# State of West Virginia Purchase Order

Order Number:	CPO 0211 4004 GSD2300000002 11	Procurement Folder:	969527
Document Name:	Building 4 Renovations Project	Reason for Modification:	Change Order #7 To increase the contract.
Document Description:	Building 4 Renovations Project		
Procurement Type:	Central Purchase Order		
Buyer Name:	Melissa Pettrey		
Telephone:	(304) 558-0094		
Email:	melissa.k.pettrey@wv.gov		
Shipping Method:	Best Way	Effective Start Date:	2022-10-03
Free on Board:	FOB Dest, Freight Prepaid	Effective End Date:	2024-12-25

## Document G701® – 2017

**PROJECT: (Name and address)**  
22010.00 Building Four Renovations  
Project  
112 California Avenue, Charleston, WV  
25305

RFI #: 78  
Date: 1/24/2024  
Job: 22-22 State Office Building 4 Renov  
Phone:

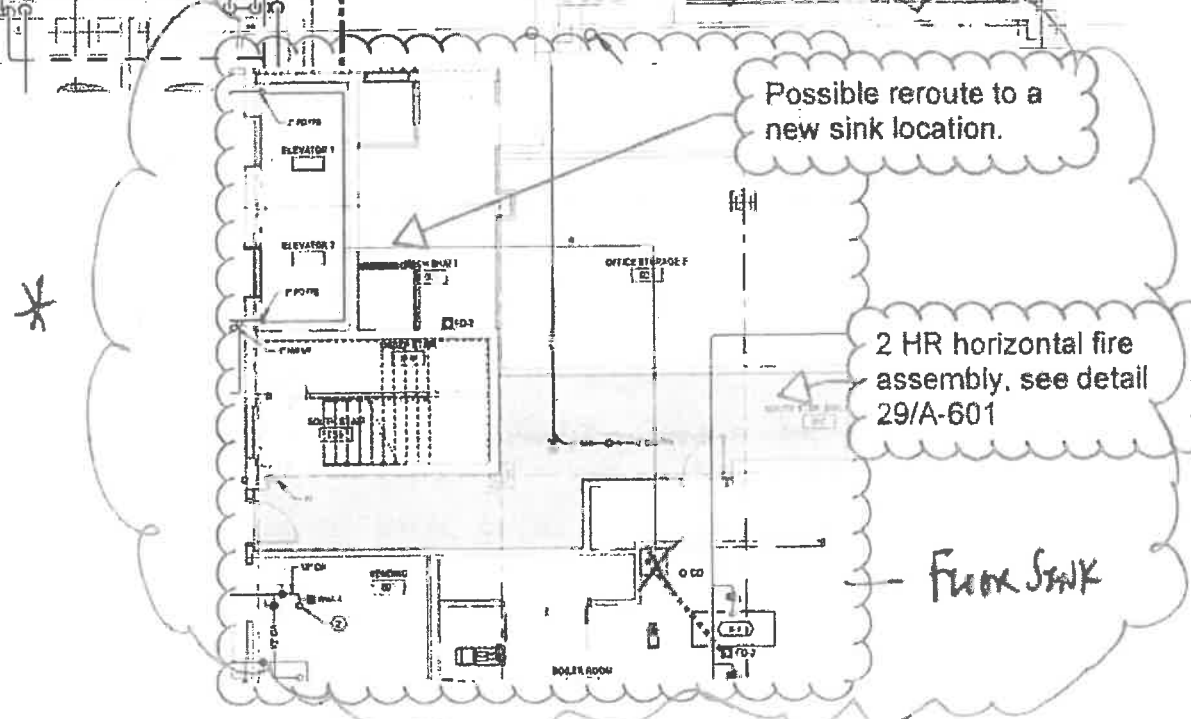
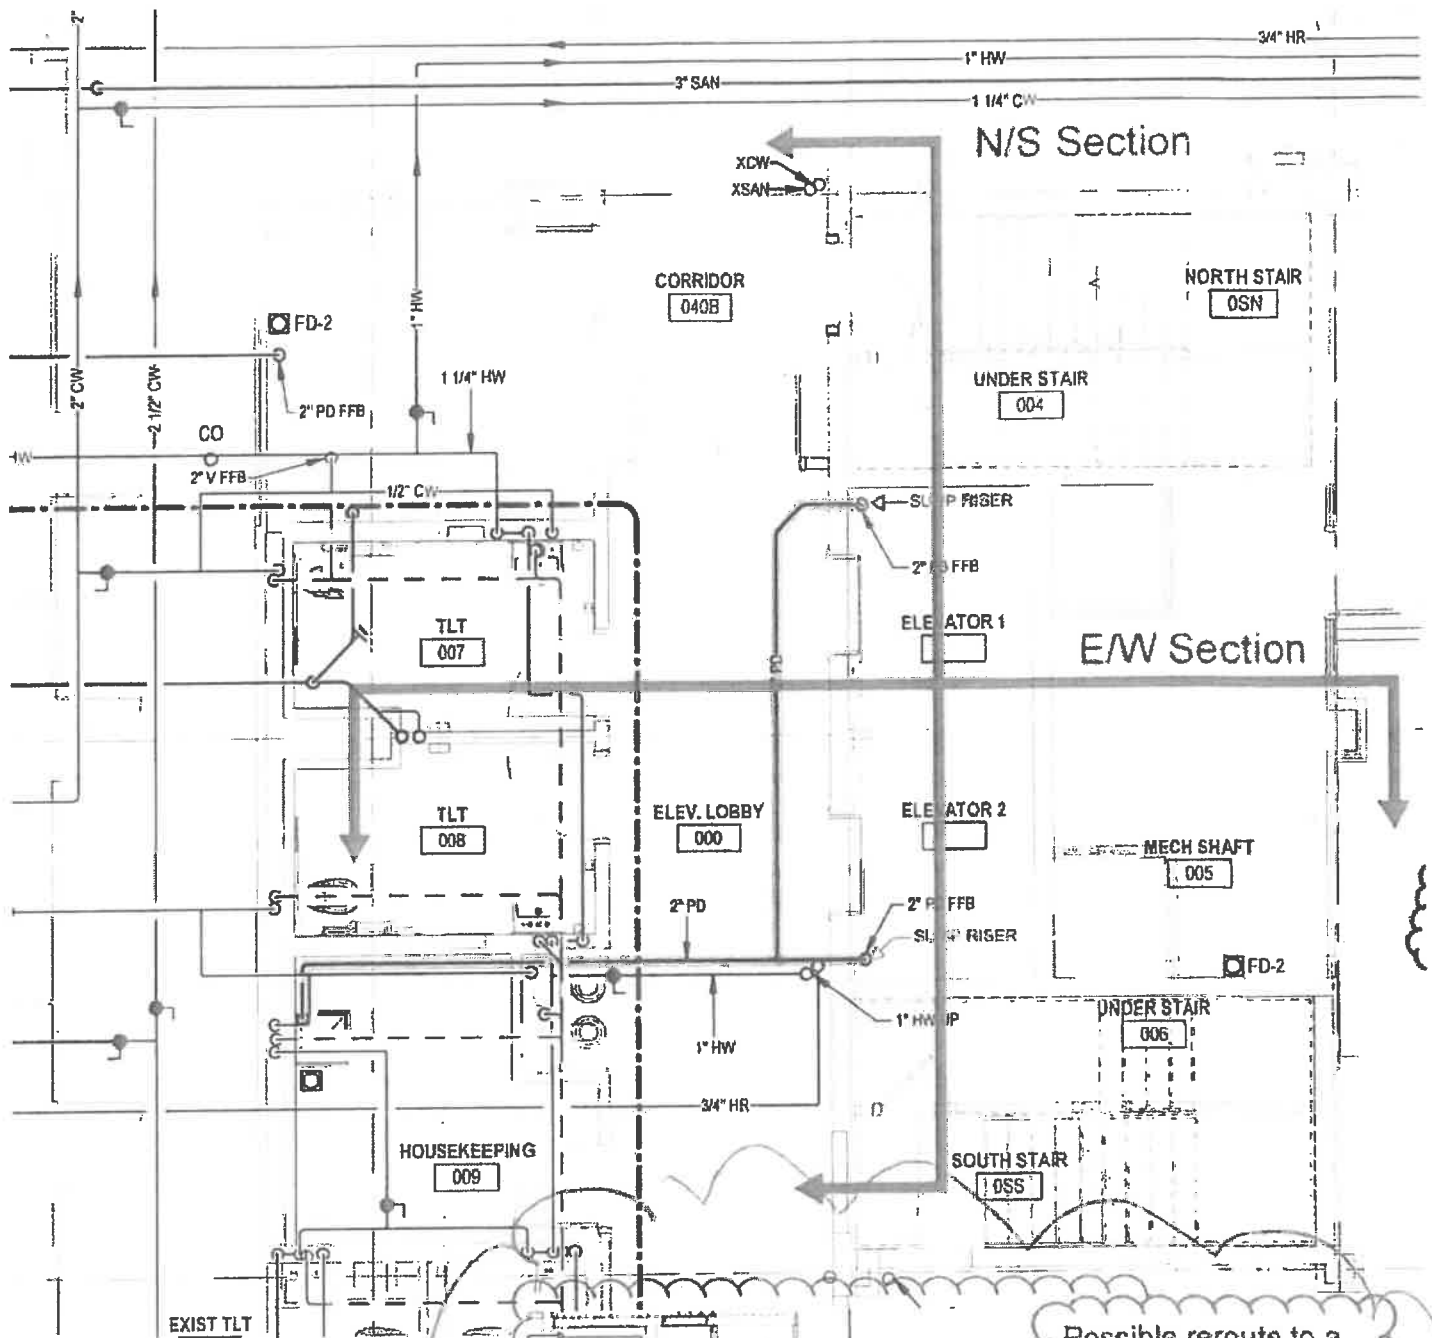
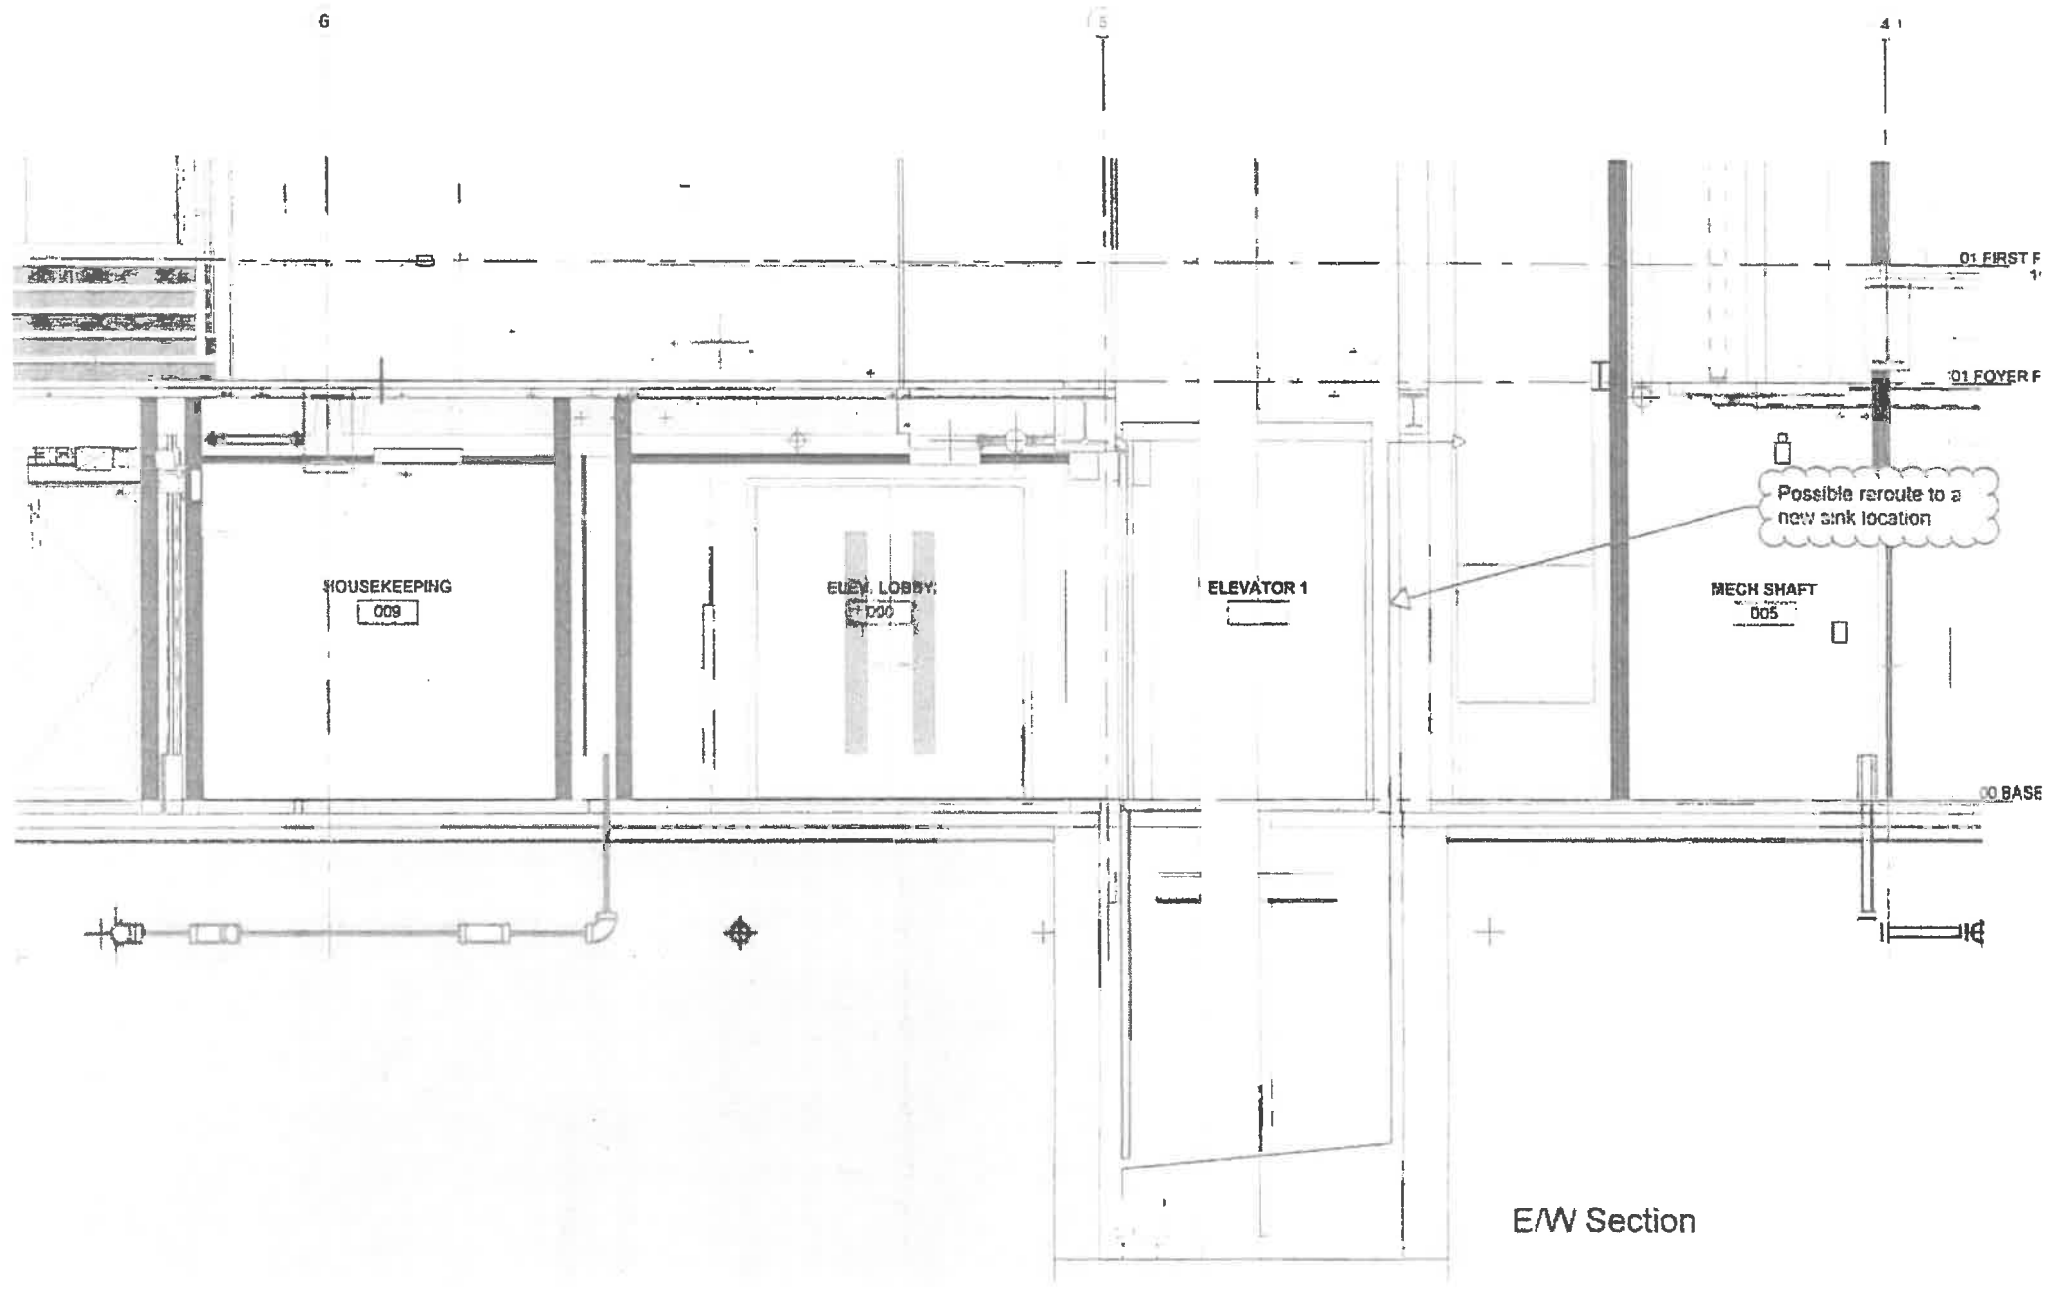
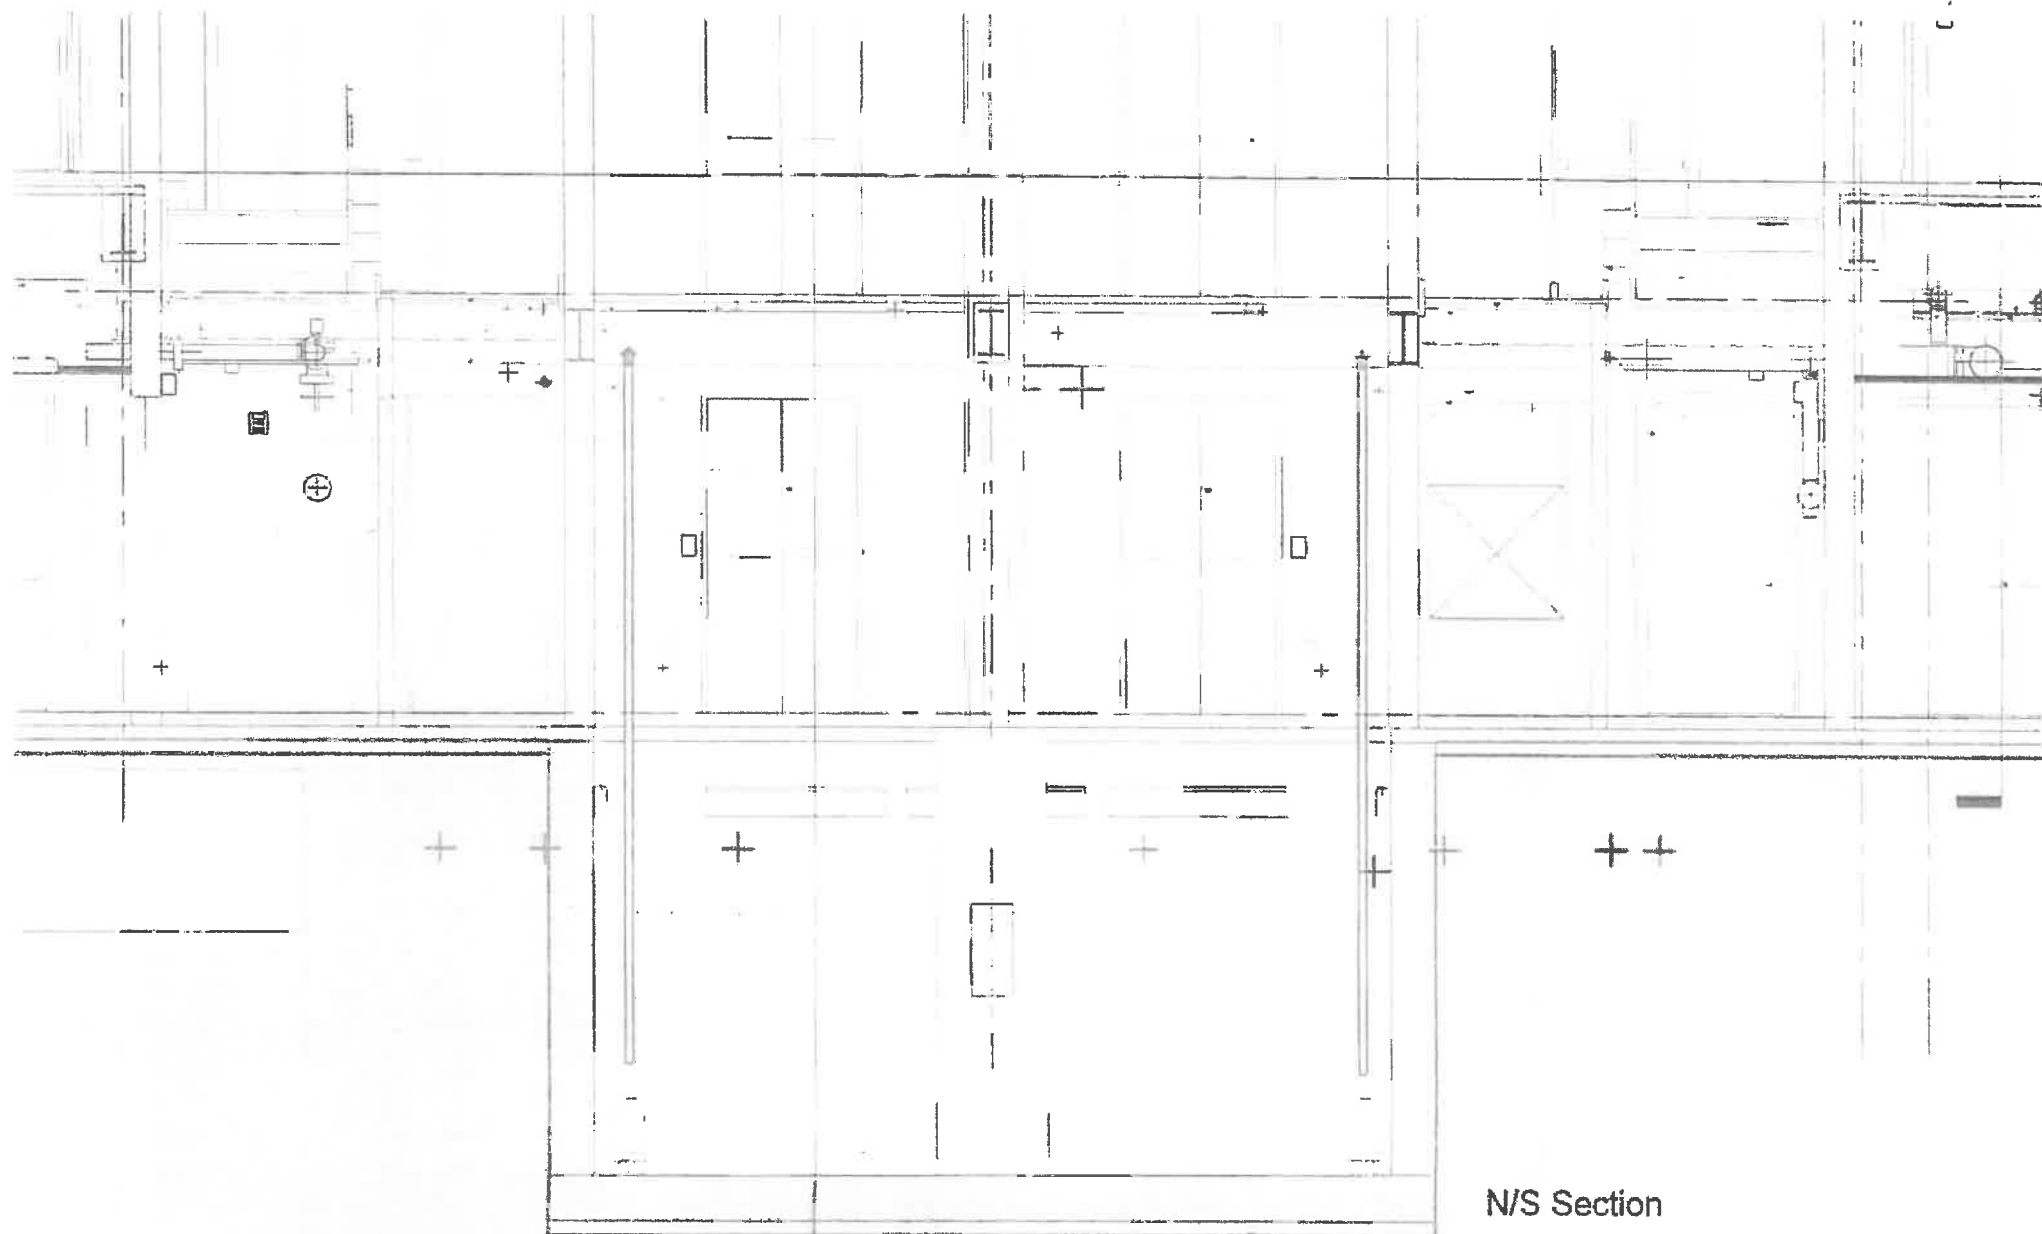
Reference Drawing P-010 and P-100 for the 2" pump discharge piping coming from the Elevator Sump Pump Pits. The drawings show the 2" pump discharge lines coming from the corners of the elevator shaft, going up the wall, stubbing through the wall from the shaft to elevator lobby above ceiling, and then running to Housekeeping Room 009 and discharging in the mop sink.

If the pipe cannot fit under the steel and above the elevator lobby ceiling, another option could be providing a slop sink in the boiler room and taking the pipe out on the other side.

**RFI #:** 95  
**Date:** 3/5/2024  
**Job:** 22-22 State Office Building 4 Renov  
**Phone:**

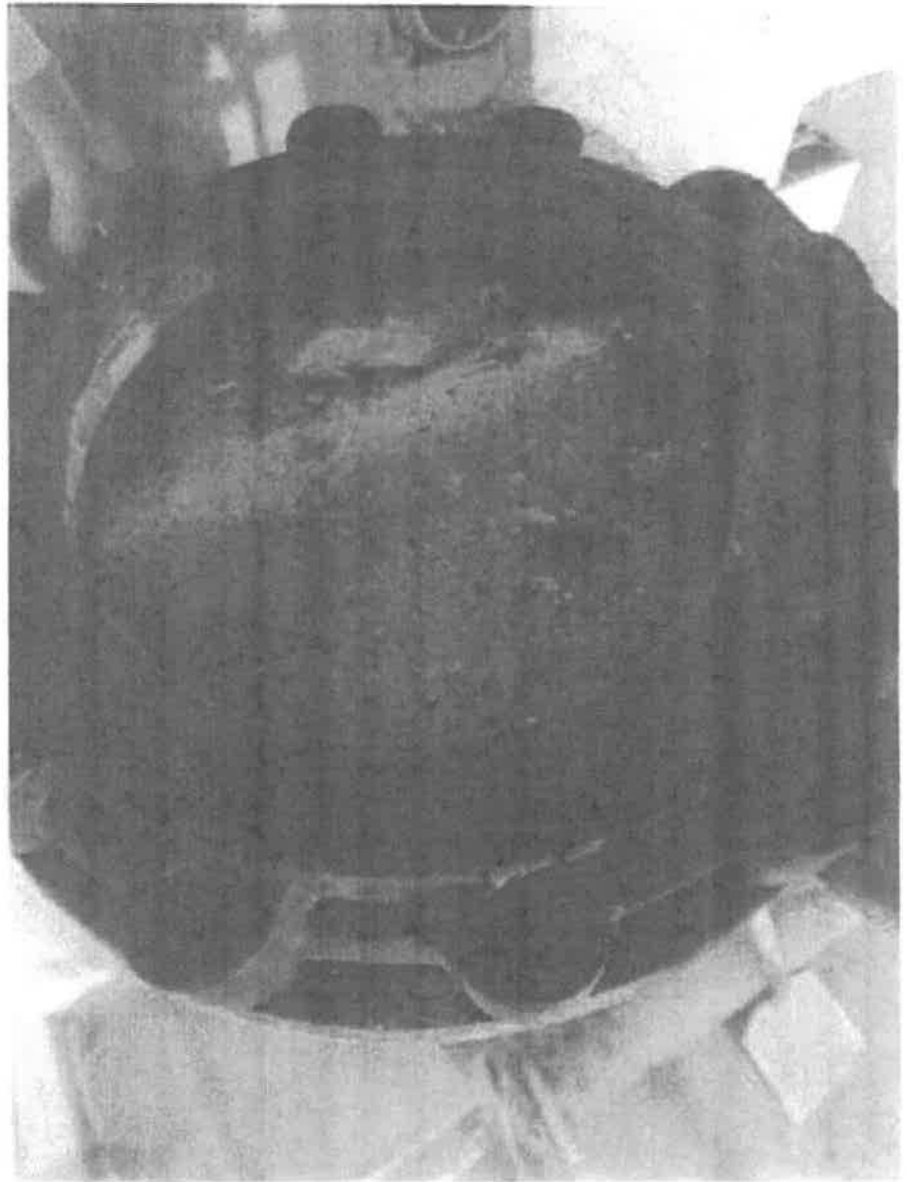
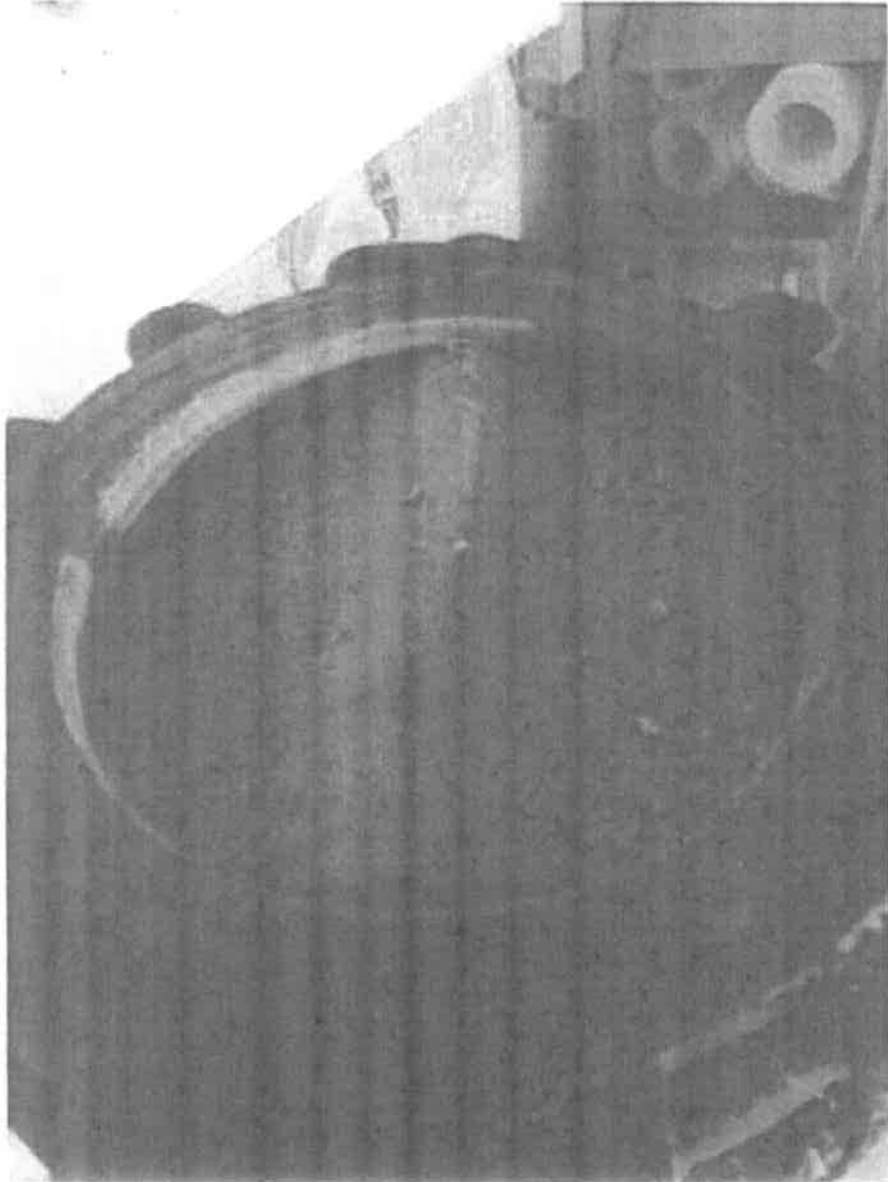
As a follow up to RFI #81 regarding the existing CWS & CWR Valves in Room 013, please see the attached photos. The neoprene seals on the existing valves at the chilled water supply and return are in very bad shape and will need replaced to make proper seal. Please advise if we are to price new neoprene seals, if the owner wants to provide them, or if you want to review again the need to replace the valves.

Please provide for owners consideration pricing to replace the neoprene seals, and pricing to replace the valves.  
Thank you.

## Change Proposal Request No.48R1

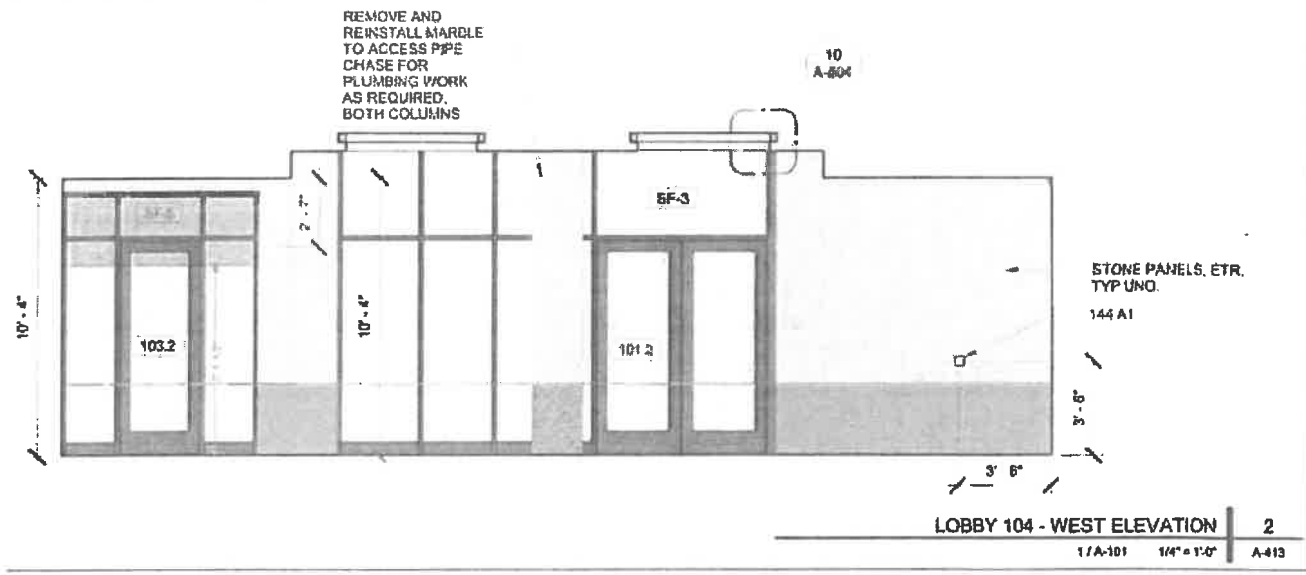
Wilson asked if they had to demo the marble bulkhead highlighted below. Before I answer, can you tell me if storefront door 103.2 has been fabricated? Thanks.

Proposal Revised to include eliminating the need to remove the marble panels shown in Detail 17 on A413. The marble will stay in place since the opening height is to remain as is.
